The following information is being submitted on behalf of the Material License application for Lawrence Park Radiologic Center and in response to questions regarding said application.

Lawrence Park Radiologic Center

New License Appl. dated 8/31/88 & Ltr. dated 10/20/88

MODEL 243

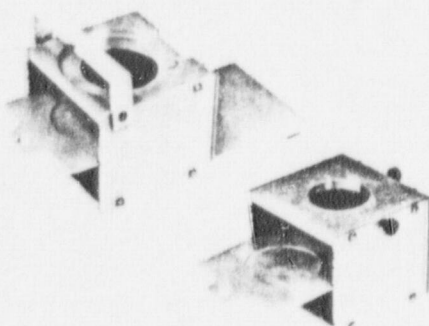
1. In order to appropriately meet the compliance item as defined in 10 CFR, Part 35.70, this facility has now approved the purchase of, and the order has been placed, for the following equipment to use as the primary instrument to count all wipe tests (to include radioactive packages and room area surveys):
 - a. Scaler/Ratemeter, mfg. Ludlum Meas. Inc., Model # 243
 - b. Shielded Well Detector, same manufacturer, Model # 2200
